Technical Service Information

THM 440-T4 / 4T60-E CONVERTER SEAL LEAK

Figure 1

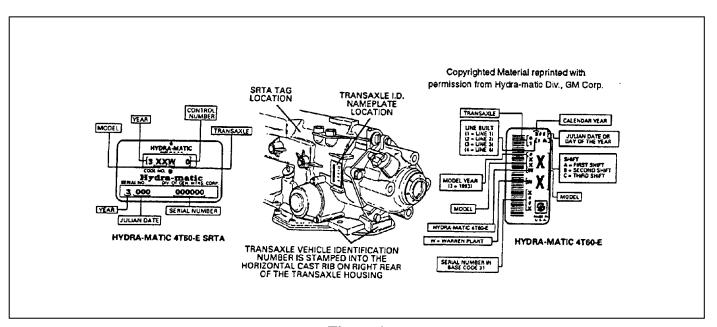
COMPLAINT: Some 1991-1993 4T60-E transaxles built on or before Oct.28,1992 ,(Julian Date 302) (SEE

FIGURE 1) may exhibit a leak at the converter housing area or the seal may completely blow

out onto the converter, especially in hot weather and/or under extreme conditions.

CAUSE: Because of the taper and surface finish of the converter seal bore, the converter seal may

become unseated and partially walk out of the converter housing.
